City of Sandy

City Council Meeting

Meeting Date: Tuesday, February 22, 2022

Please note: there will be an opportunity to provide testimony for the Deer Meadows Subdivision Appeal later in the agenda.

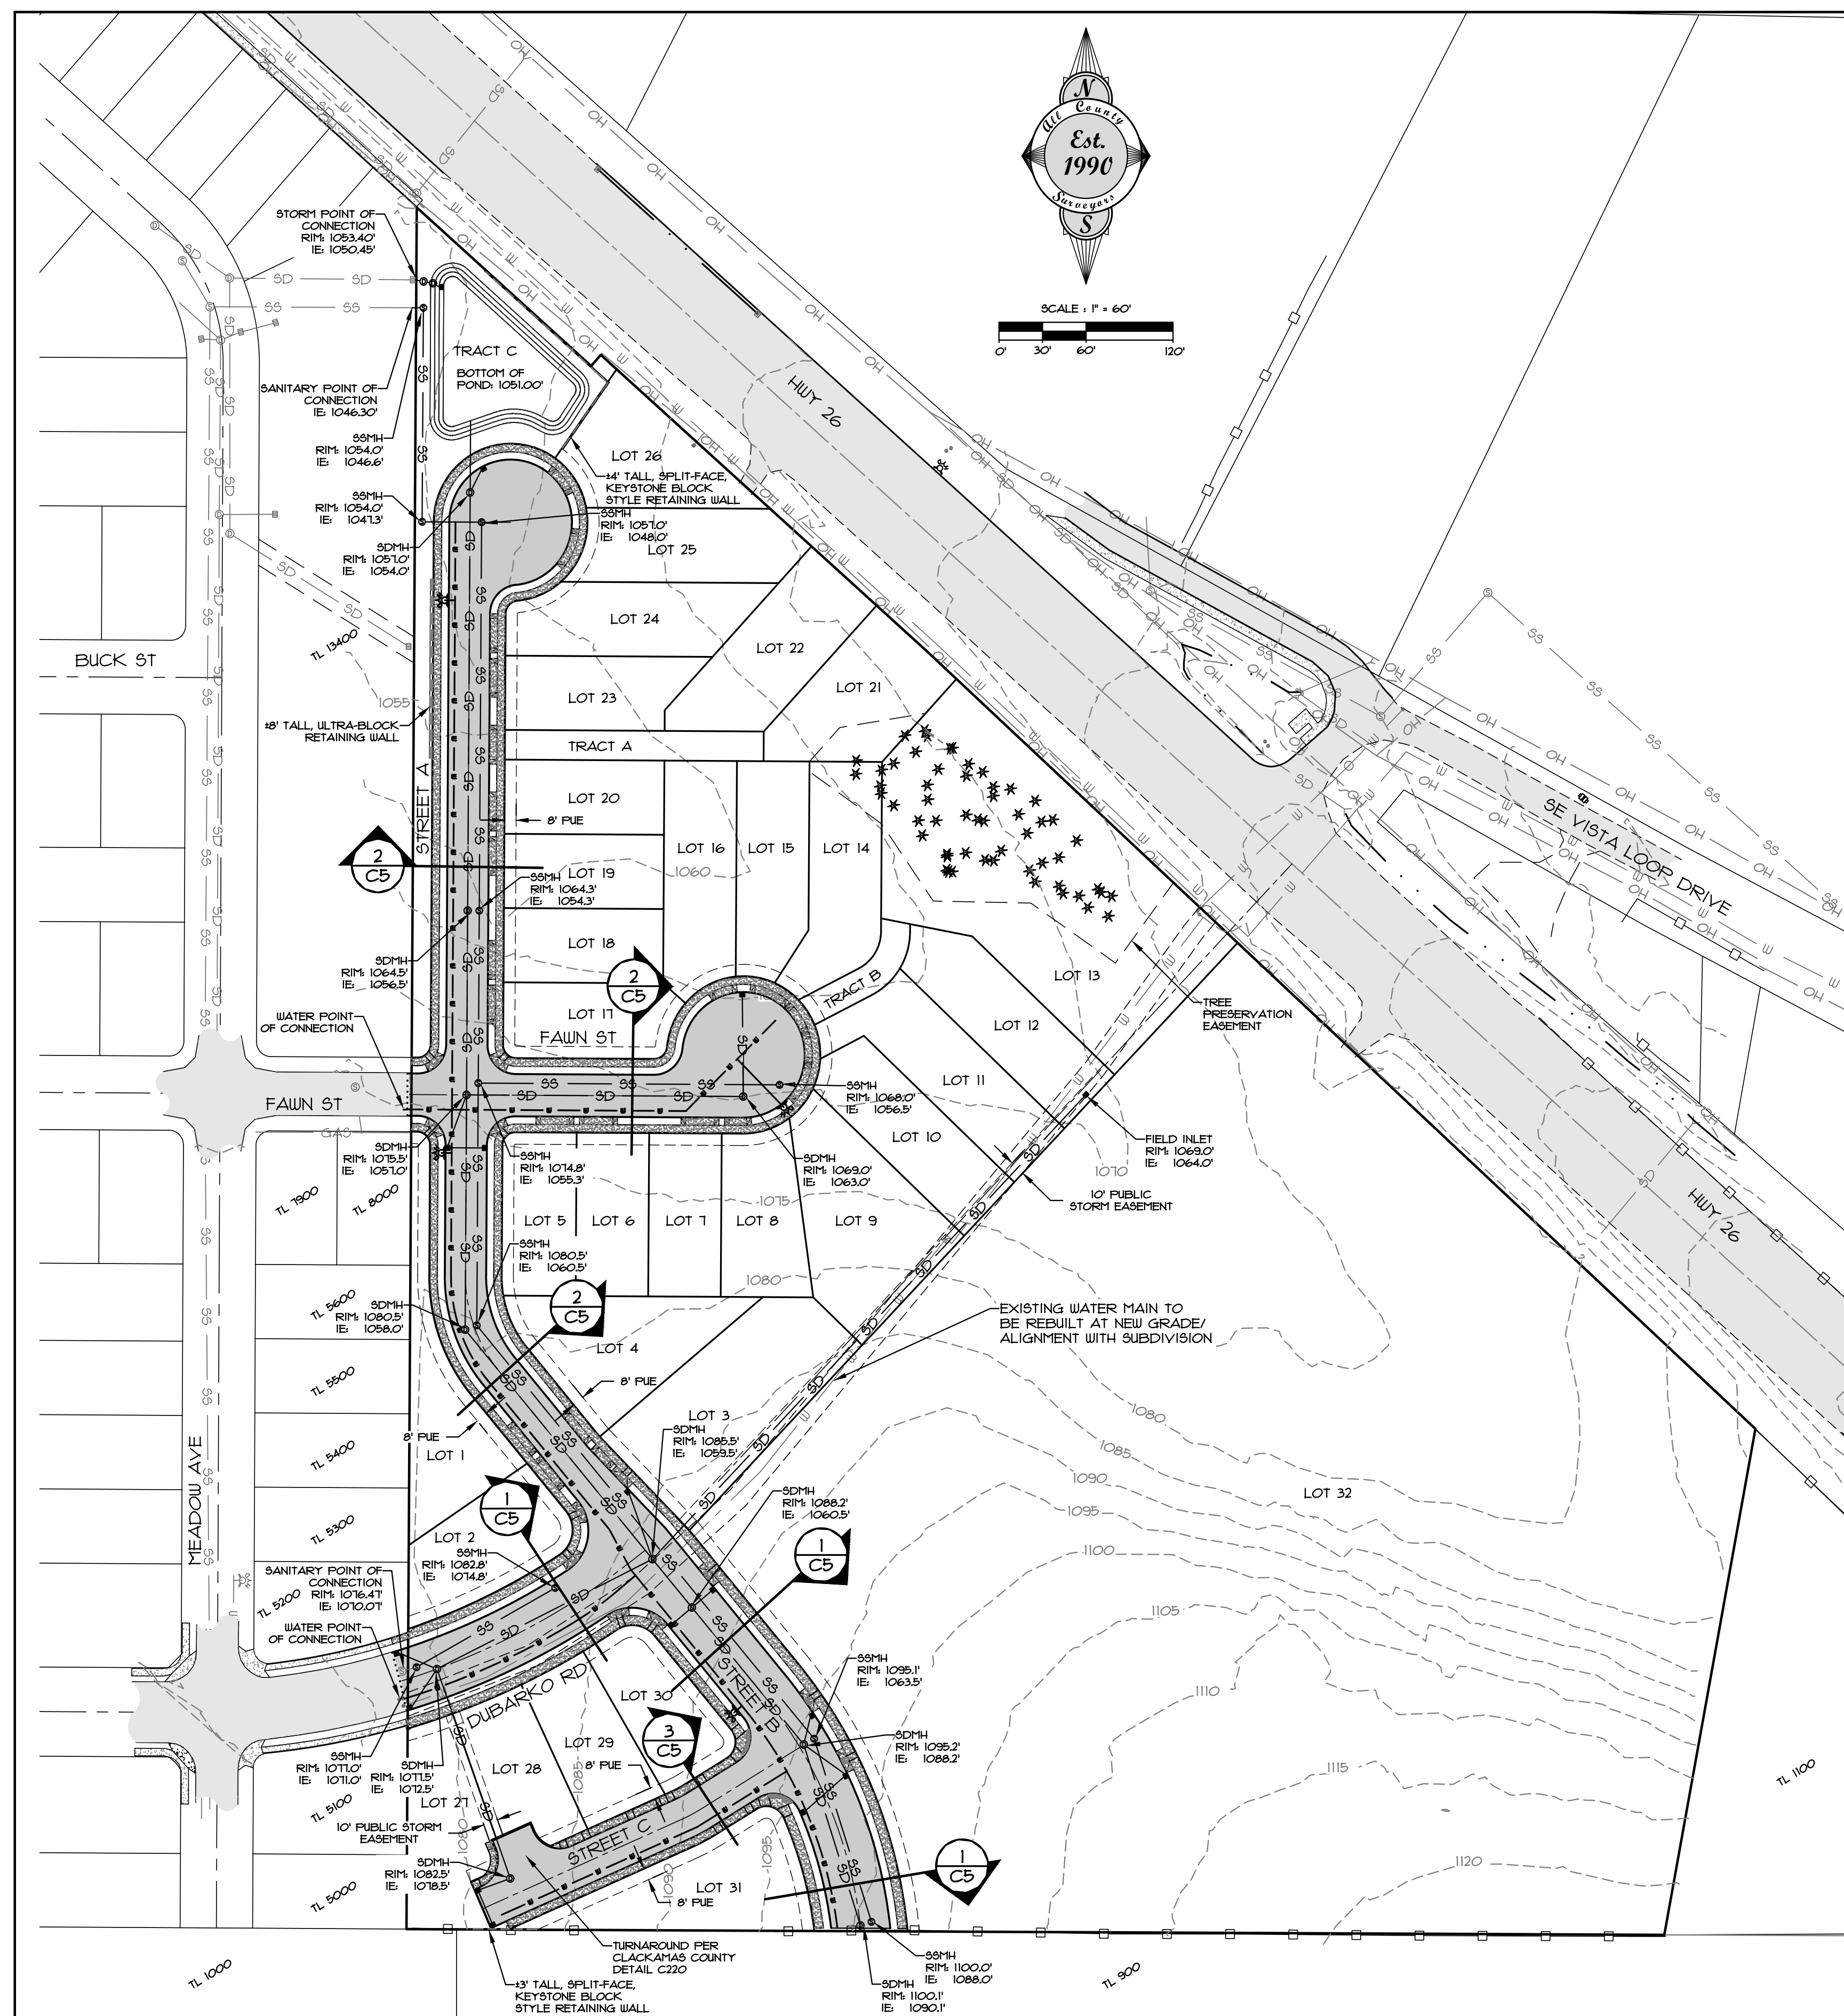
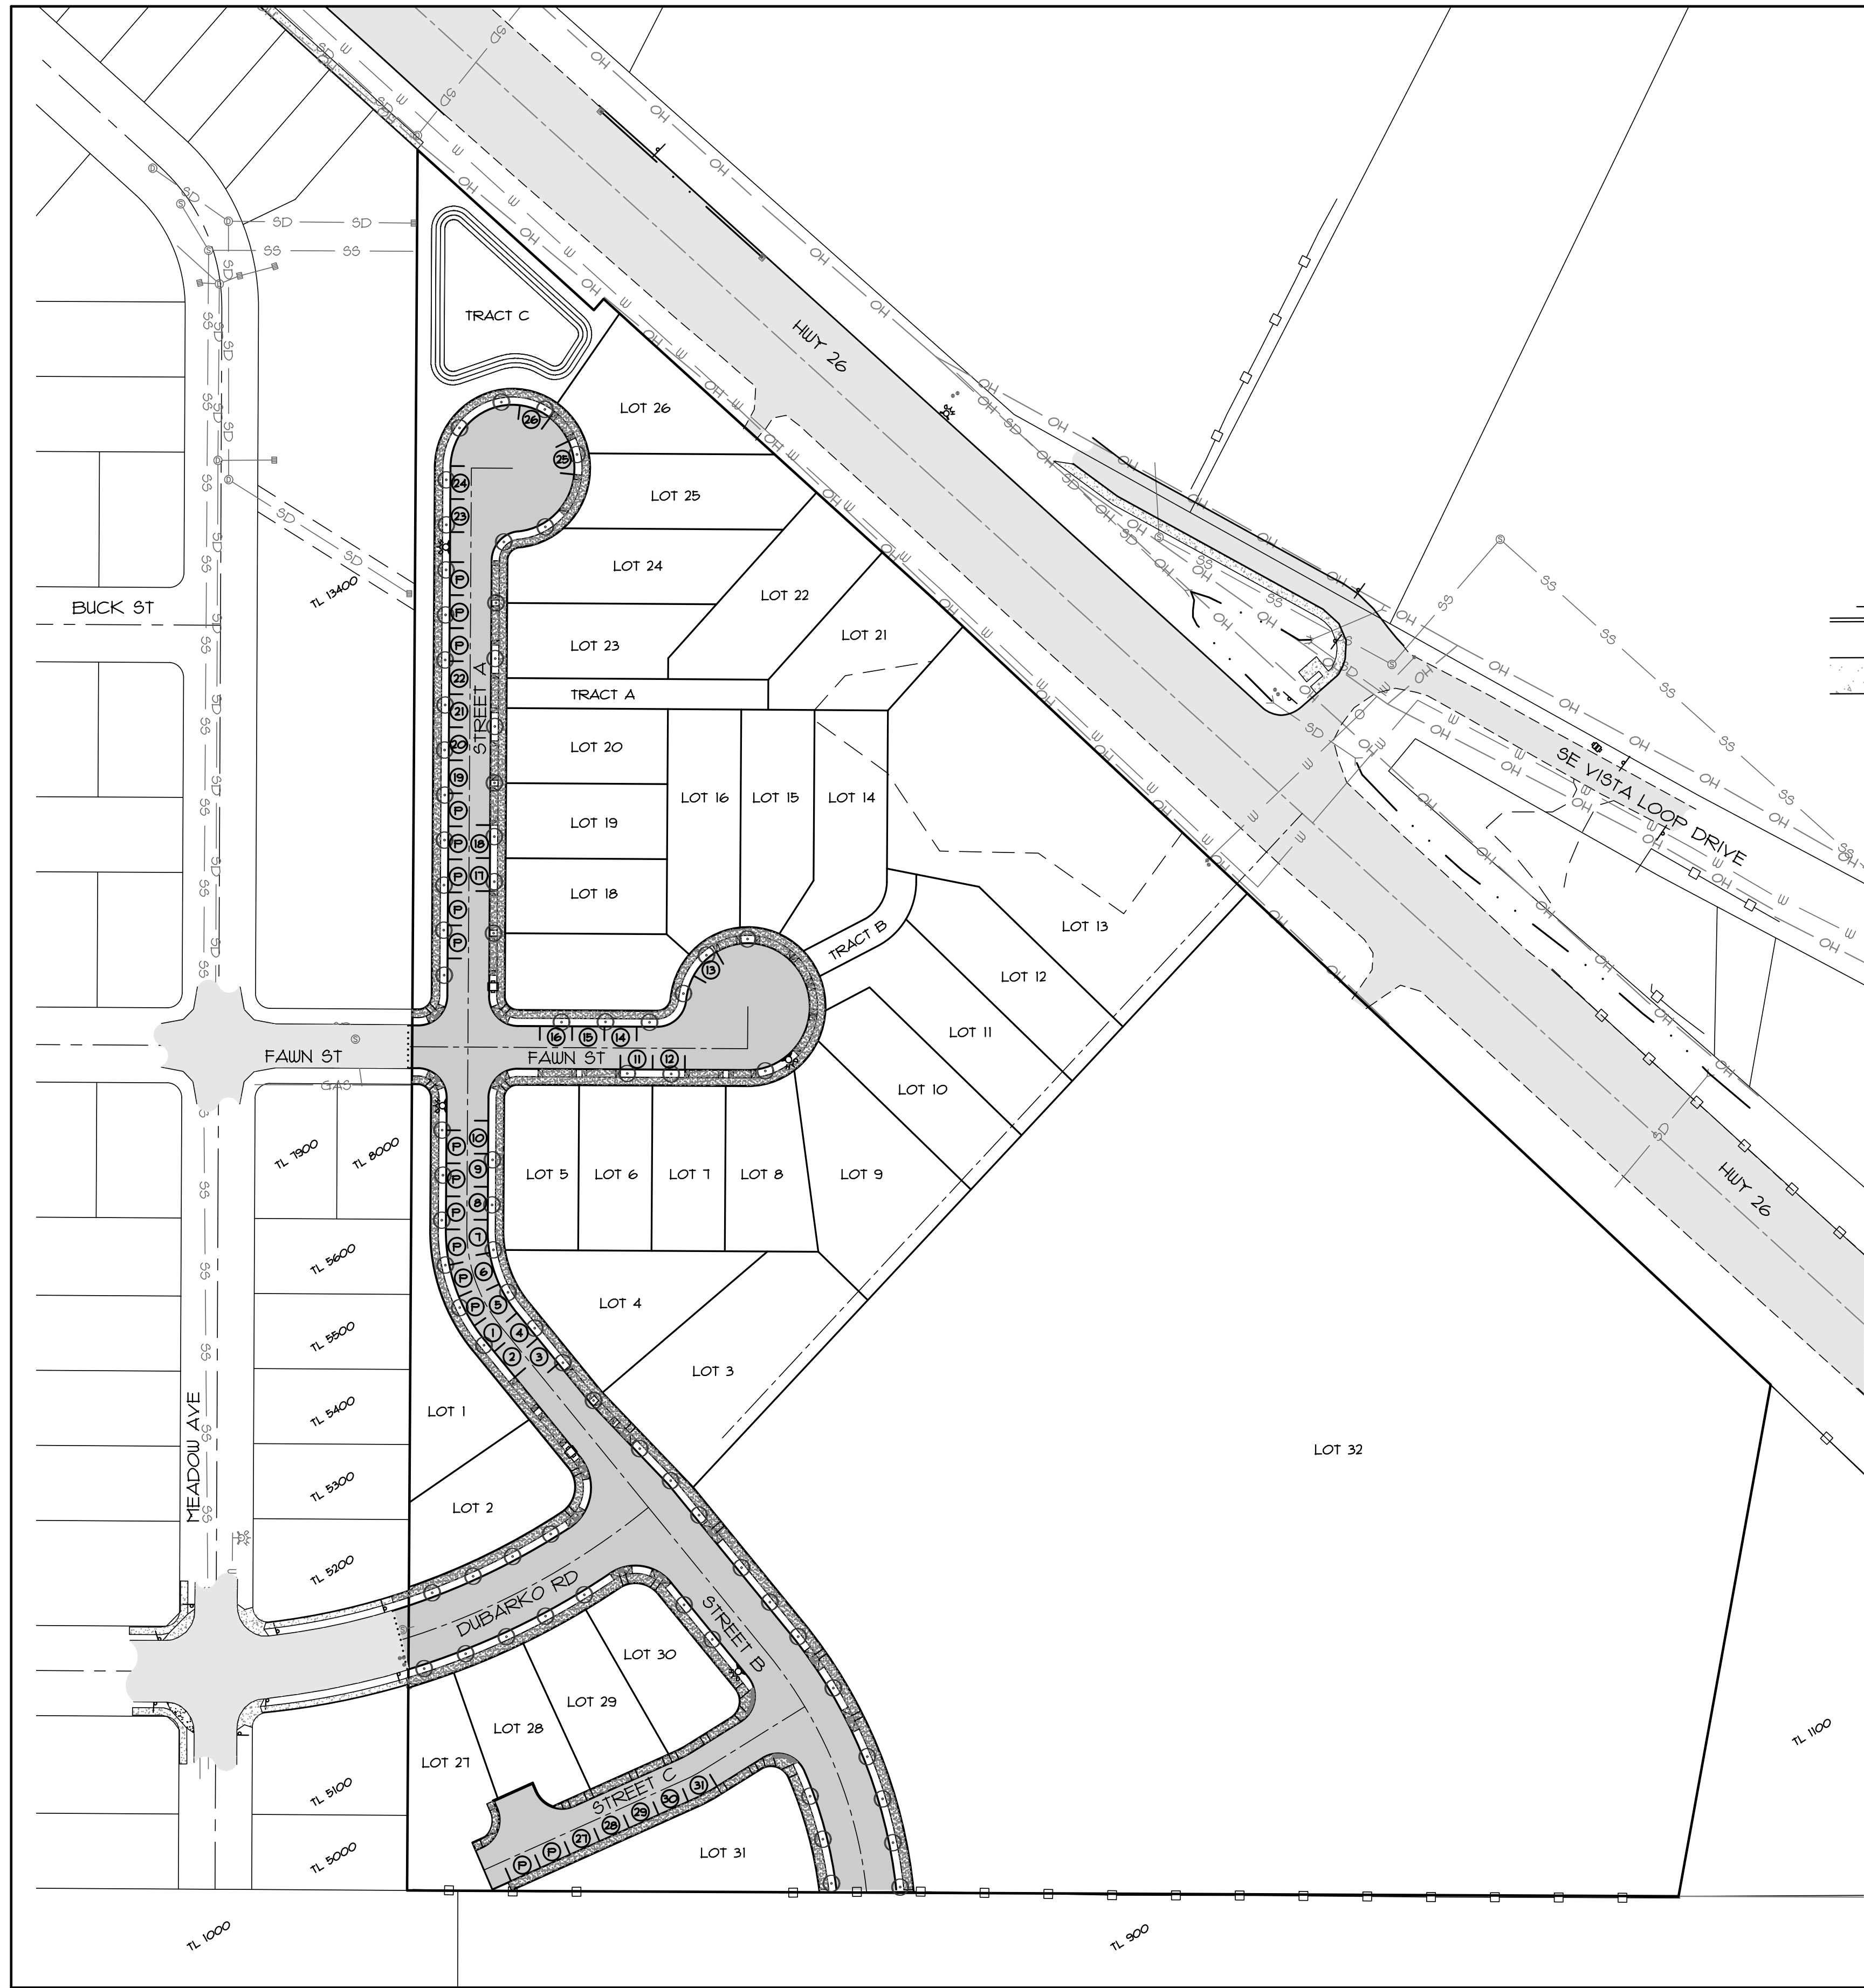
Sheet C5 of the applicant's submission contains a statement indicating that "Both of the proposed cul-de-sacs have less than 50% of their circumference covered by driveway drops". No dimensional information is shown on the site plan to support this statement. The location, number and width of all driveway approaches in cul-de-sacs shall not exceed the dimensional standards in section 17.98.100 SMC.

RESPONSE: **Exhibit 2**, attached hereto, provides driveway width information for the Fawn Street and Street A cul-de-sacs. This exhibit demonstrates that the sum of the driveway widths for each cul-de-sac is less than 50%. SDC 17.98.100.F is satisfied.

STREET TREE PLAN & PARKING ANALYSIS

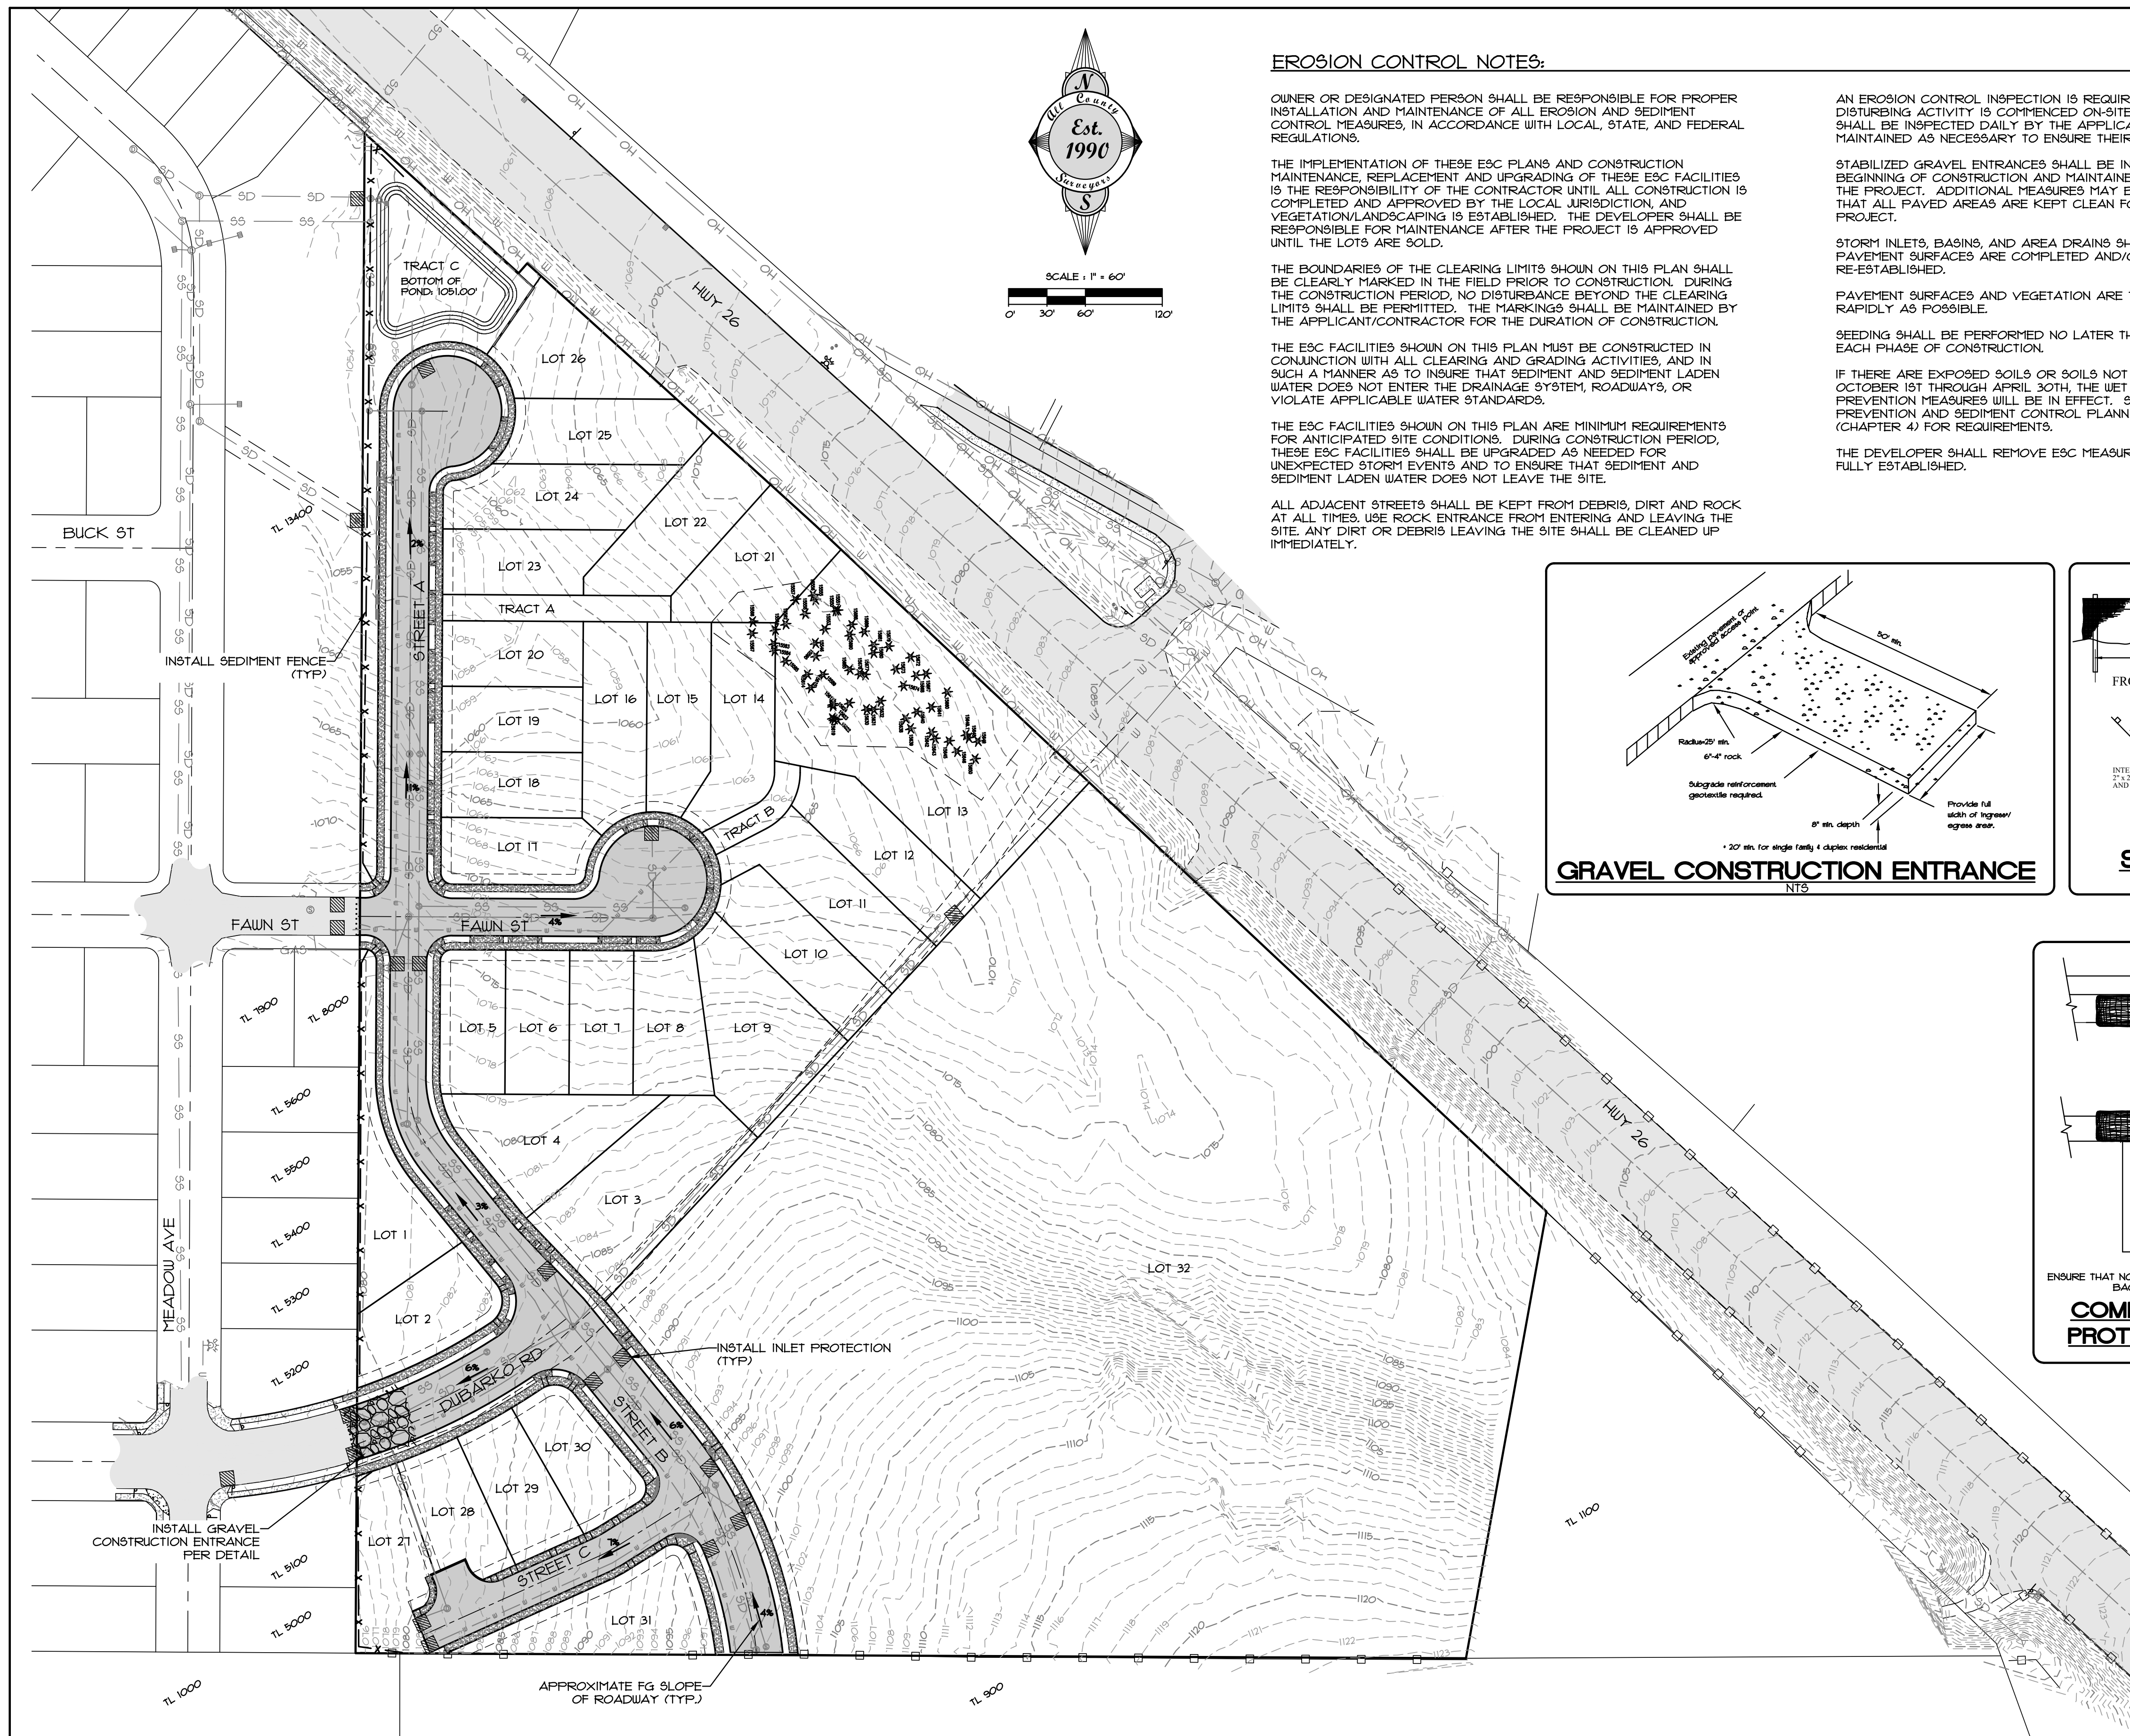
63. Section 17.98.10(M) requires that the developer provide a Residential Parking Analysis Plan. This plan identifying the location of parking for the 30 R-1 zoned lots is included in Exhibit C, Sheet C6.

has been identified within 300 feet of each of the 30 lots zoned as R-1 as required. Exhibit C, Sheet C6 shows that 47 on-street parking spaces have been identified in compliance with this standard. No parking courts are proposed by the applicant.
